Device **XC866-4FR**
Marking/Step **BC**
Package **PG-TSSOP-38**

This Errata Sheet describes the deviations from the current user documentation. The module oriented classification and numbering system uses an ascending sequence over several derivatives, including already solved deviations. So gaps inside this enumeration can occur.

Figure 1 Critical Cases for Power up/ Power down when $V_{residual} > 500mV$

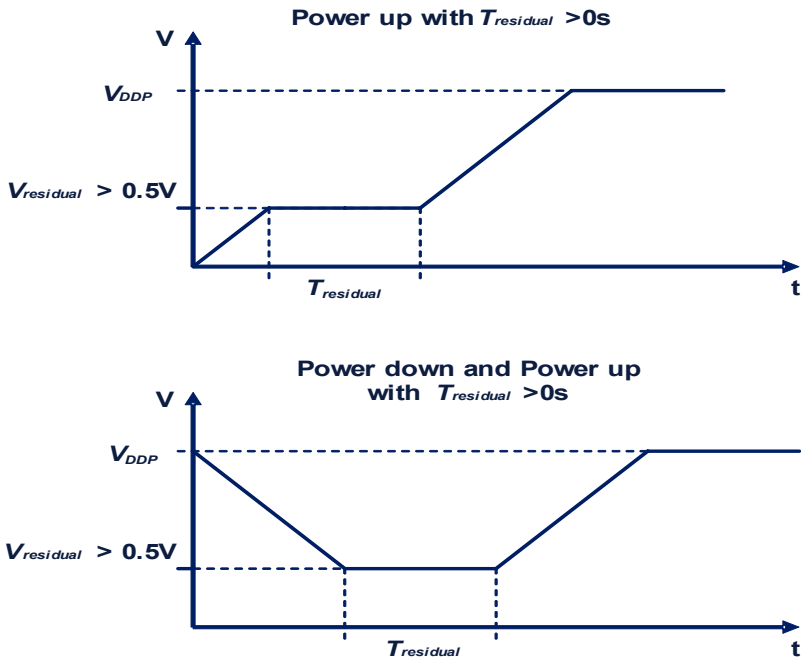
Due to the limitation of the EVR, the reset toggling may occur during the power up. To prevent the reset toggling issue for power up, the following conditions must be met :

1. For power up, the rising time must be less than 2ms/V.
2. The power down time must be more than 0.2ms/V.
3. A permanent V_{DDP} residual voltage is less than 500mV.

In case of V_{DDP} residual voltage is more than 500mV, the holding time of residual voltage affects the reset toggling issue. **Figure 1** shows the critical cases for power up/power down when the residual voltages is held for some time. **Figure 2** shows the uncritical case for power up and power down when the power up is triggered immediately after power down. In case of a residual voltage due to immediate power up after power down, the users have to contact IFX to ensure no power up failure.

INT_XC8.003 Unintended External Interrupt 0/1 Request in Bypass Edge Detection Mode

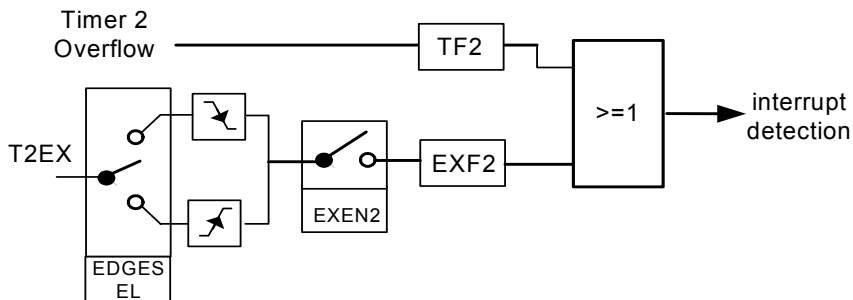
For external interrupt 0 or 1 in bypass edge detection mode with falling edge as the active event, clearing the IRCON0.EXINT0/1 flag while the pin input is still low will lead to the internal circuitry falsely detecting a falling edge event. This will lead to unintended interrupt request.

Never clear the IRCON0.EXINT0/1 flag in bypass edge detection mode. Access the TCON.IE0/1 flag directly instead, if necessary (TCON.IE0/1 flag is cleared automatically by hardware on vectoring to the interrupt routine).

Figure 3

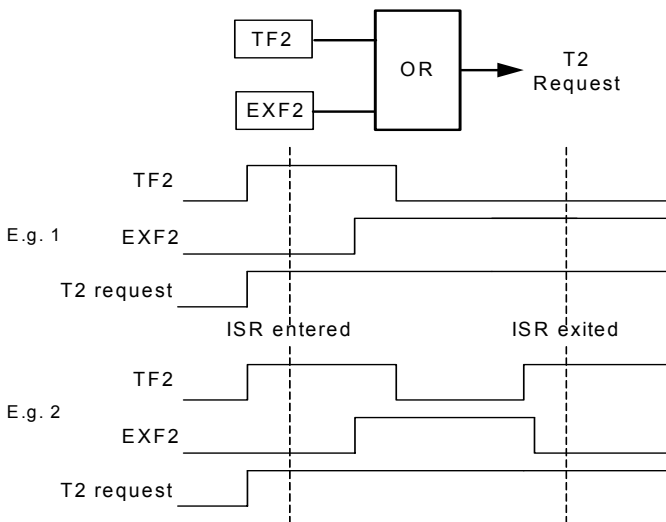
As illustrated in the simplified figure, the Timer 2 interrupt flags TF2 and EXF2 are combined as one interrupt request output. These flags are located within the Timer 2 kernel, with a single interrupt request line as output from the kernel.

Being of interrupt structure 2, the interrupt request of Timer 2 is detected on the rising edge of a positive pulse.

The problem is that it may occur at some point in the application, that any new Timer 2 interrupt request can no longer be detected after a return-from-interrupt (reti) due to service of earlier event(s). This happens when the following conditions are true:

1. Timer 2 events are serviced by interrupt (i.e. flags are checked and cleared only in the interrupt routine ISR),
2. Either TF2 or EXF2 is set at any one time throughout the ISR (even while the other is cleared) such that at least one of the flags is still set after reti, causing the Timer 2 request line, which is an OR-function of the two flags TF2 and EXF2, to remain set throughout the ISR and after reti.

There is no problem if EXF2 is not enabled by setting bit EXEN2 = 0 i.e. external events are disabled, or if bit DCEN = 1 in auto-reload mode.

Otherwise if EXF2 is enabled, while TF2 is always enabled when Timer 2 is running, there are two suggested workaround:

1. If other events of Timer 2 interrupt node (ET2) need not be enabled for interrupt, disable this interrupt node and use software polling of the flags instead.
2. Before return from interrupt, check again if TF2 or EXF2 is (still) set (due to new request since the last check). If so, jump and execute the ISR routine from start. Exit only when all flags are checked to be cleared. However, dummy interrupt of the node may occur after return from interrupt, and should be ignored. Another drawback is if Timer 2 events are occurring at high rate, the CPU may be 'stuck' in the service routine of the Timer 2 interrupt for a long time.

Figure 6

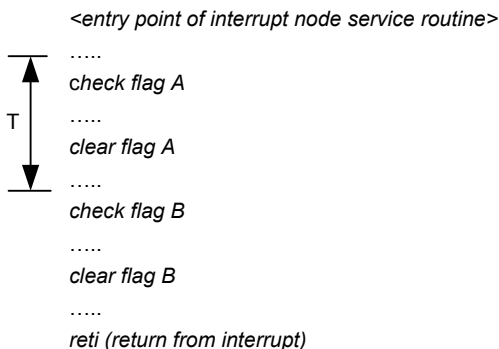
Consider the following interrupt service routine pseudo-code, and scenario where a interrupt source A event leads to interrupt request of the node and CPU vectors to the interrupt routine. Meanwhile, interrupt source B and its flag becomes active any time in the duration indicated by T:

In this case, flag B will be cleared as a standard procedure by the interrupt routine in the current service of the interrupt node. However, the pending

interrupt request for the node remains activated after RETI, as it is only cleared by hardware when CPU acknowledge the interrupt and vectors to the interrupt routine.

This leads to following servicing of the interrupt node again, but potentially no active flag is found, i.e. dummy interrupt service. The point to note is that the interrupt source B is not lost, as it was actually serviced in the current service of the interrupt node.

The recommendation is to ignore these dummy interrupt vectoring.

INT_XC8.H002 Effect of Interrupt Node Enable Bit on Interrupt Behavior

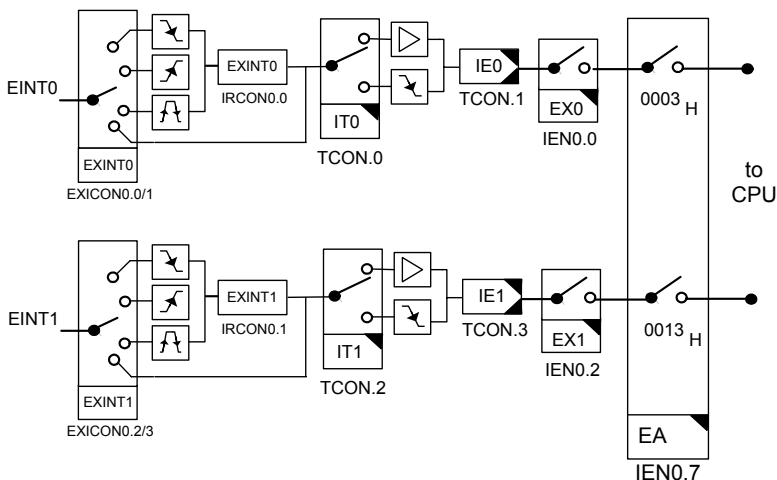
When the interrupt event occurs while the respective $IEN_x.y$ bit is disabled, the interrupt status flag will be set but the interrupt request will not be captured. Hence, enabling the respective $IEN_x.y$ bit later will not result in the CPU servicing the interrupt node for the prior interrupt event.

Clearing the $IEN_x.y$ bit of a node will clear its pending interrupt request.
